Subject: Work Plan Addendum, Draft Environmental Assessment and Characterization Work Plan,
CSMRI Flood Plain Site, by S.M. Stoller Corporation

Work Plan Addendum

CSMRI
Flood Plain Site Characterization

Figure 1-2
Current Site Location Map

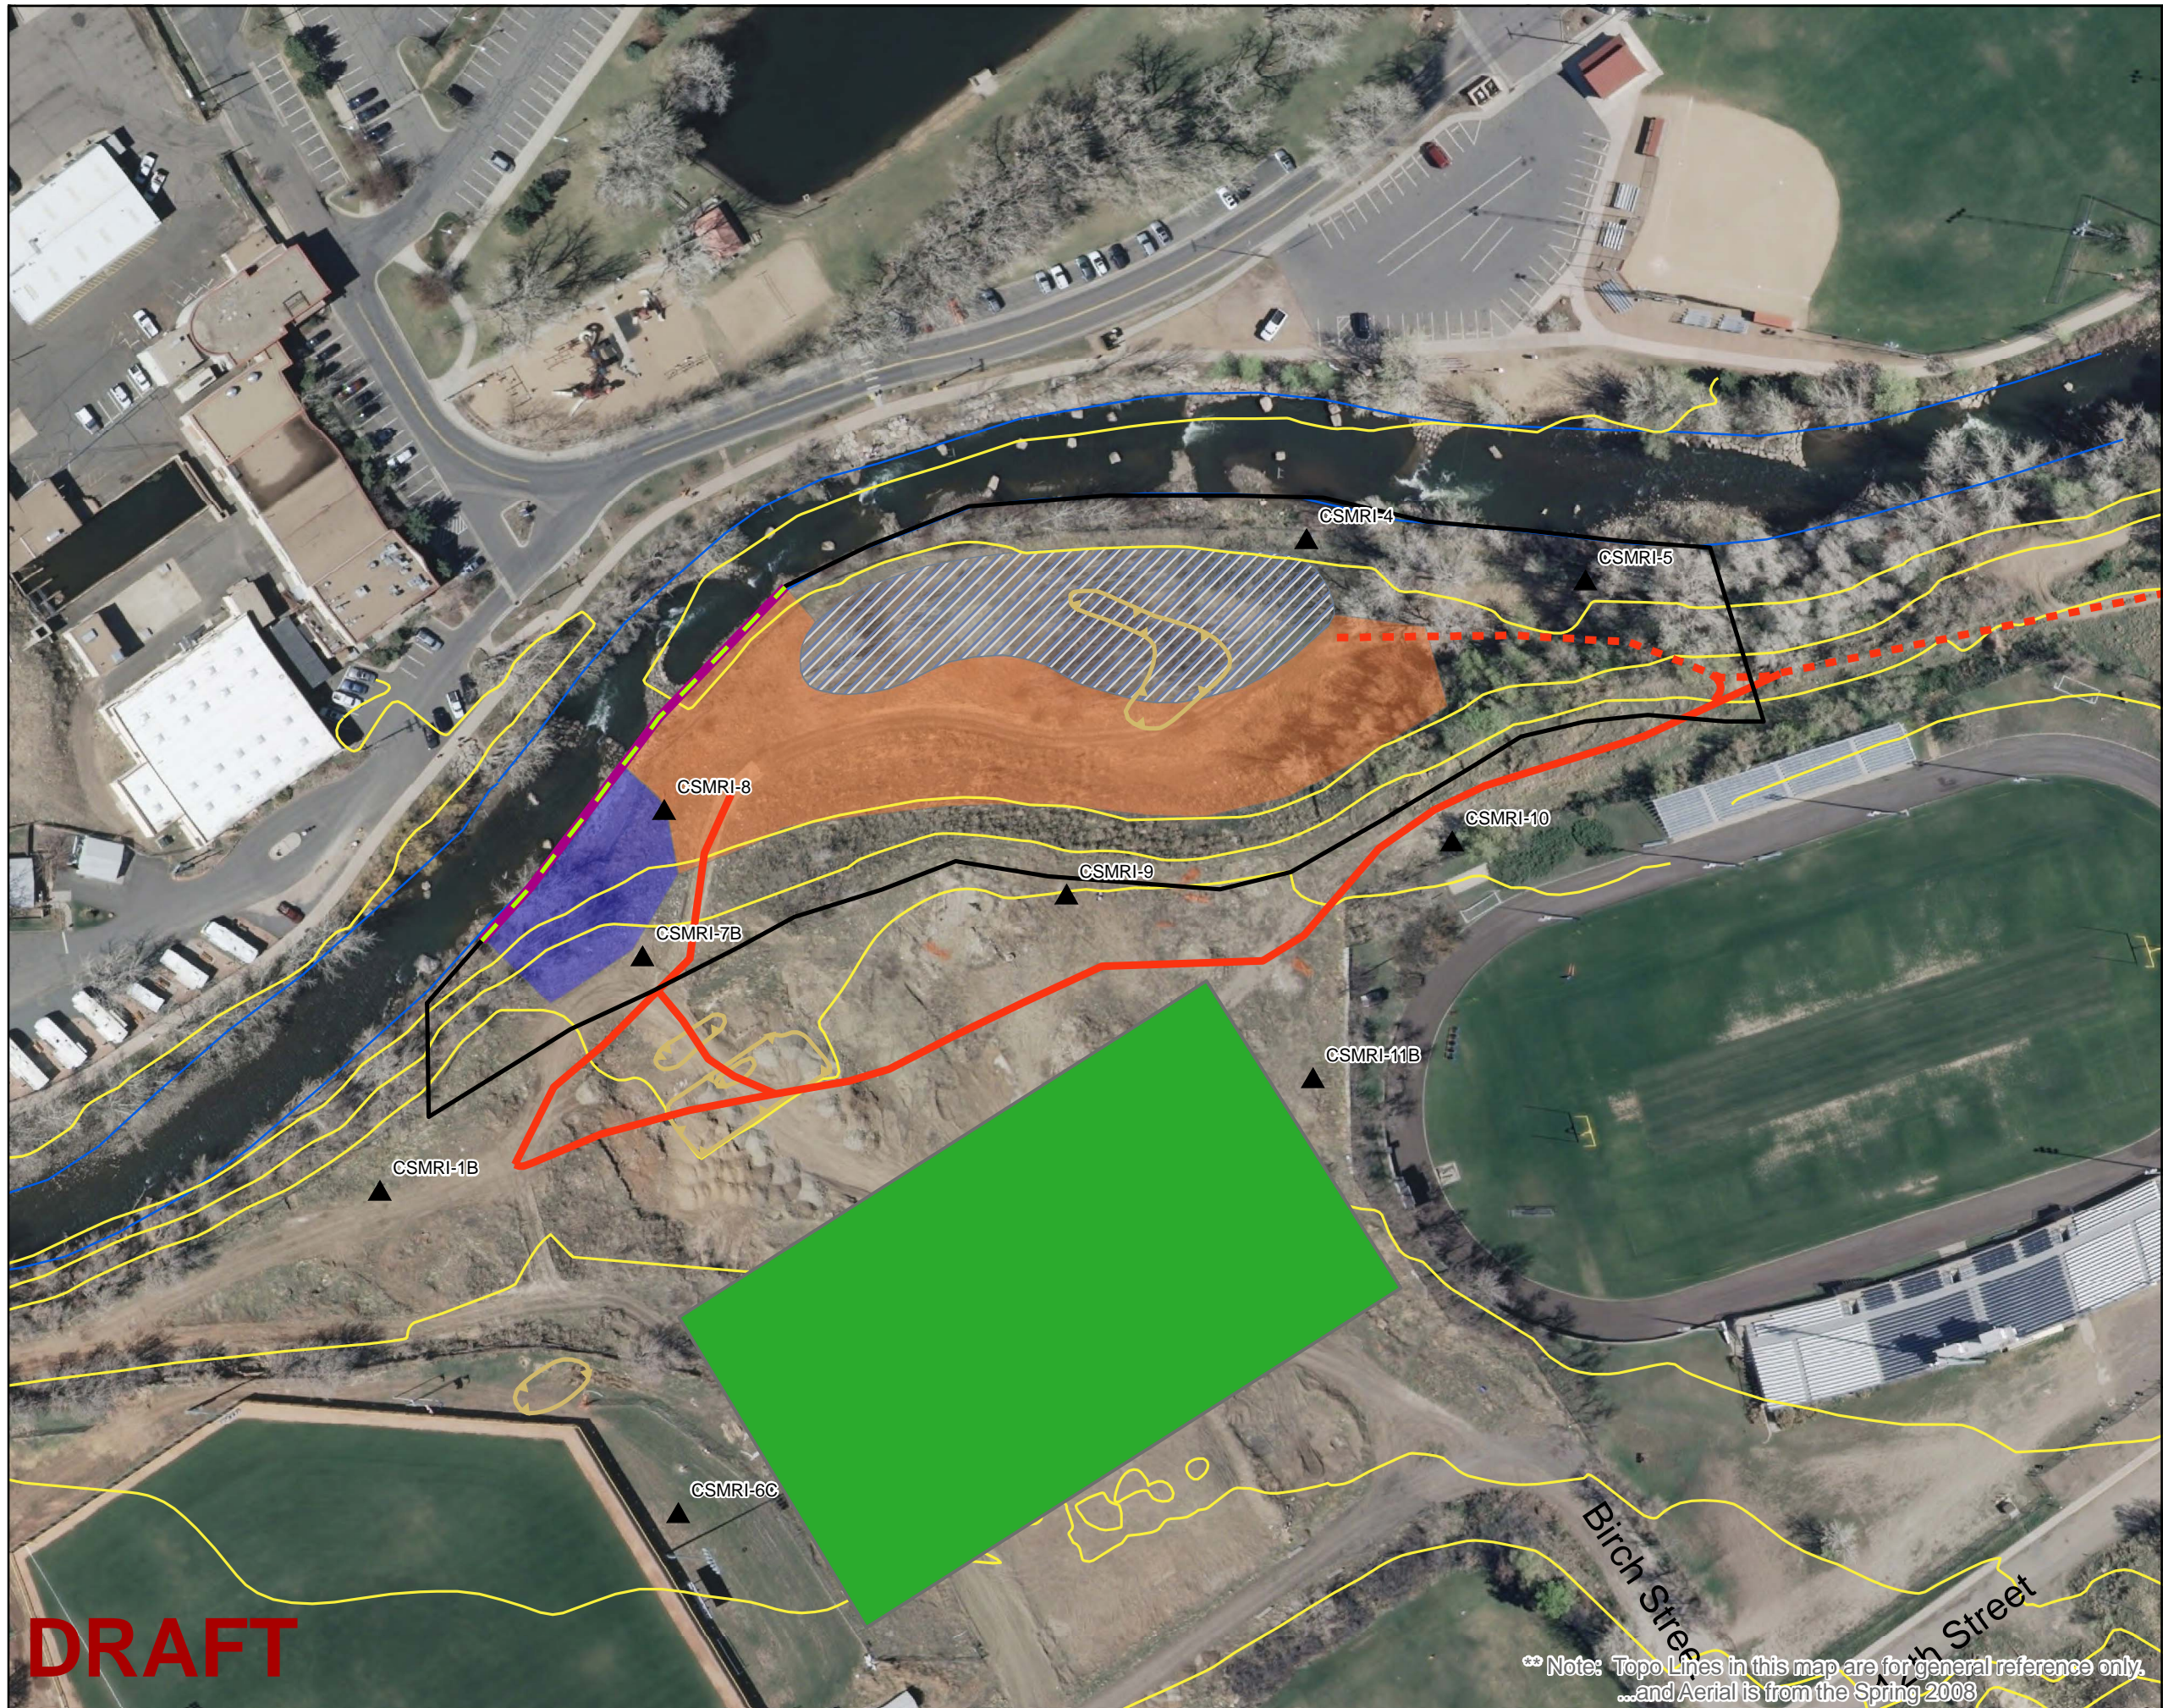
Low Permeability Barrier Wall

After further discussions with wetland experts, we decided that a barrier designed to reduce the quantity of oxygen-rich creek water entering the flood plain will enhance our chances of creating self-sustaining wetlands. The barrier will also reduce the quantity of groundwater we have in our excavations. The planned barrier will consist of a bentonite slurry wall installed in the location shown on Figure 1-2. The slurry wall will be one bucket in width or approximately 2 feet and will extend from the ground surface to the bedrock contact. The wall will be keyed into bedrock where able, including the upper most reach up Clear Creek.

Figure 4-1
Site Layout

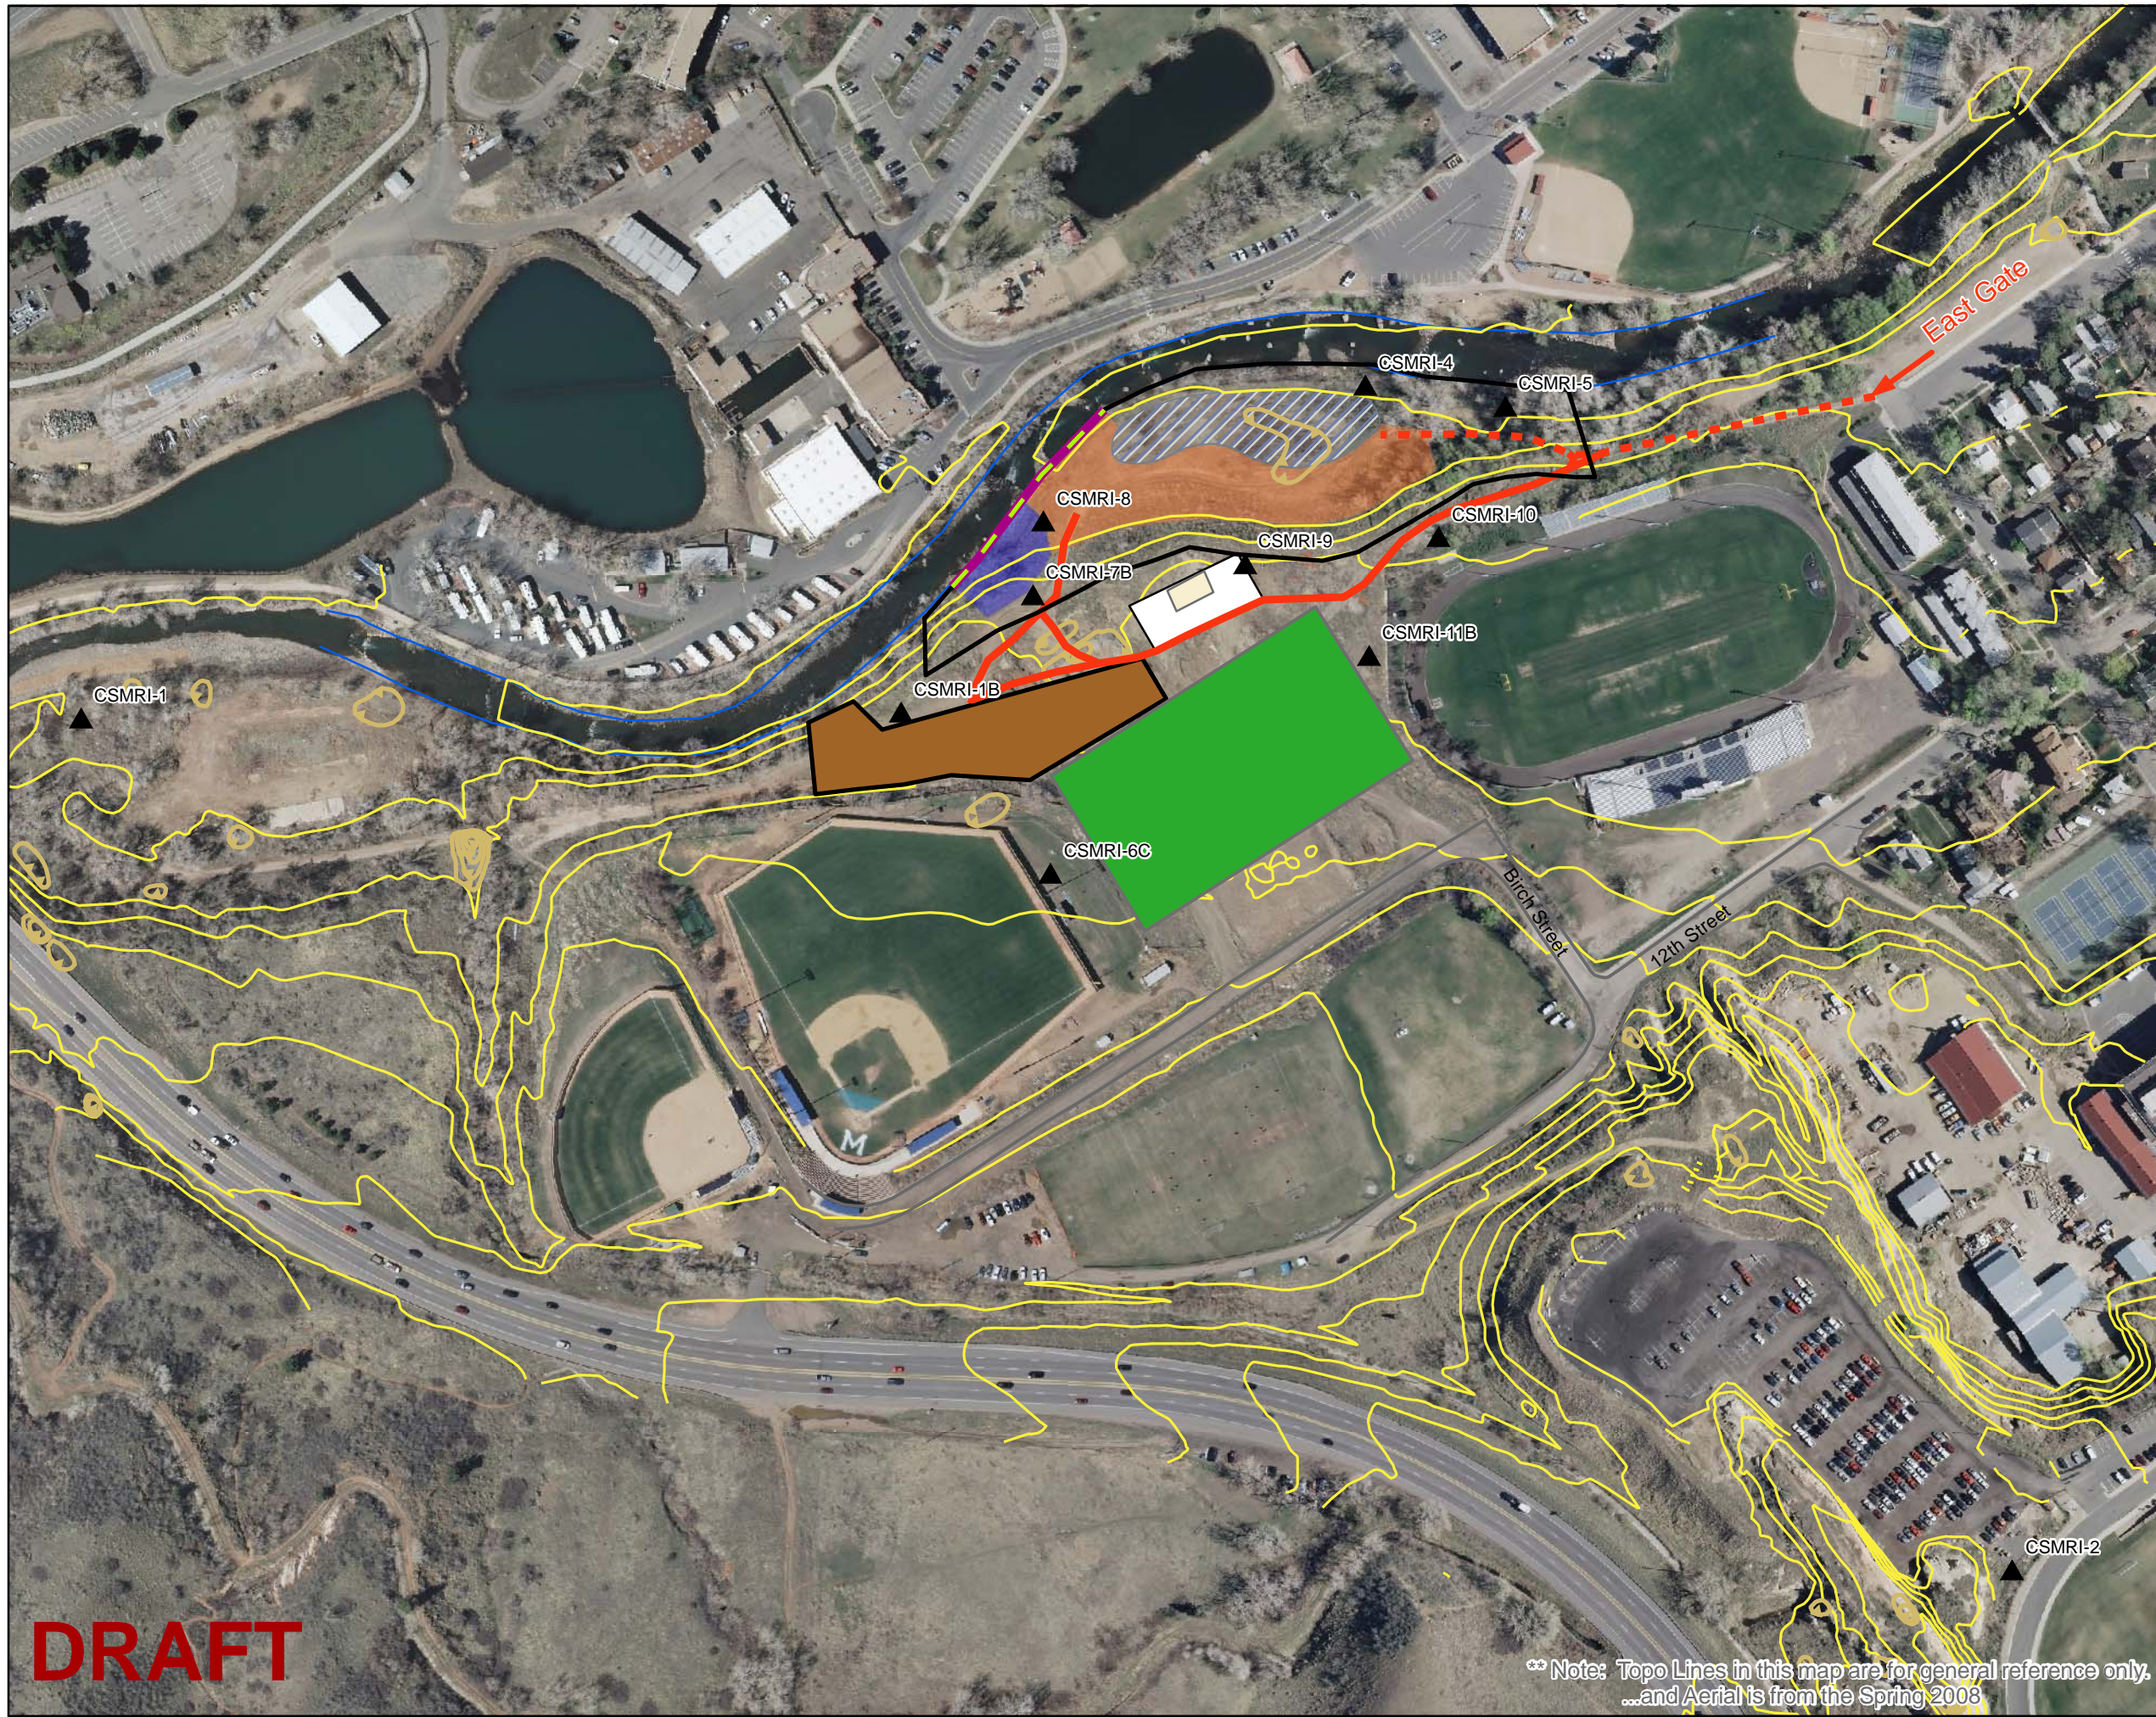
Stockpile Relocation

The original Draft Work Plan depicted the impacted material stockpile as being located west of the west gate just below 6th Avenue. After careful consideration and improved understanding of the construction work the City was planning in this area, we have moved the intended location of this stockpile to within the boundaries of the original Site. The revised location is on the upper terrace between the new soccer field and the Site's west gate as depicted on the revised Figure 4-1.
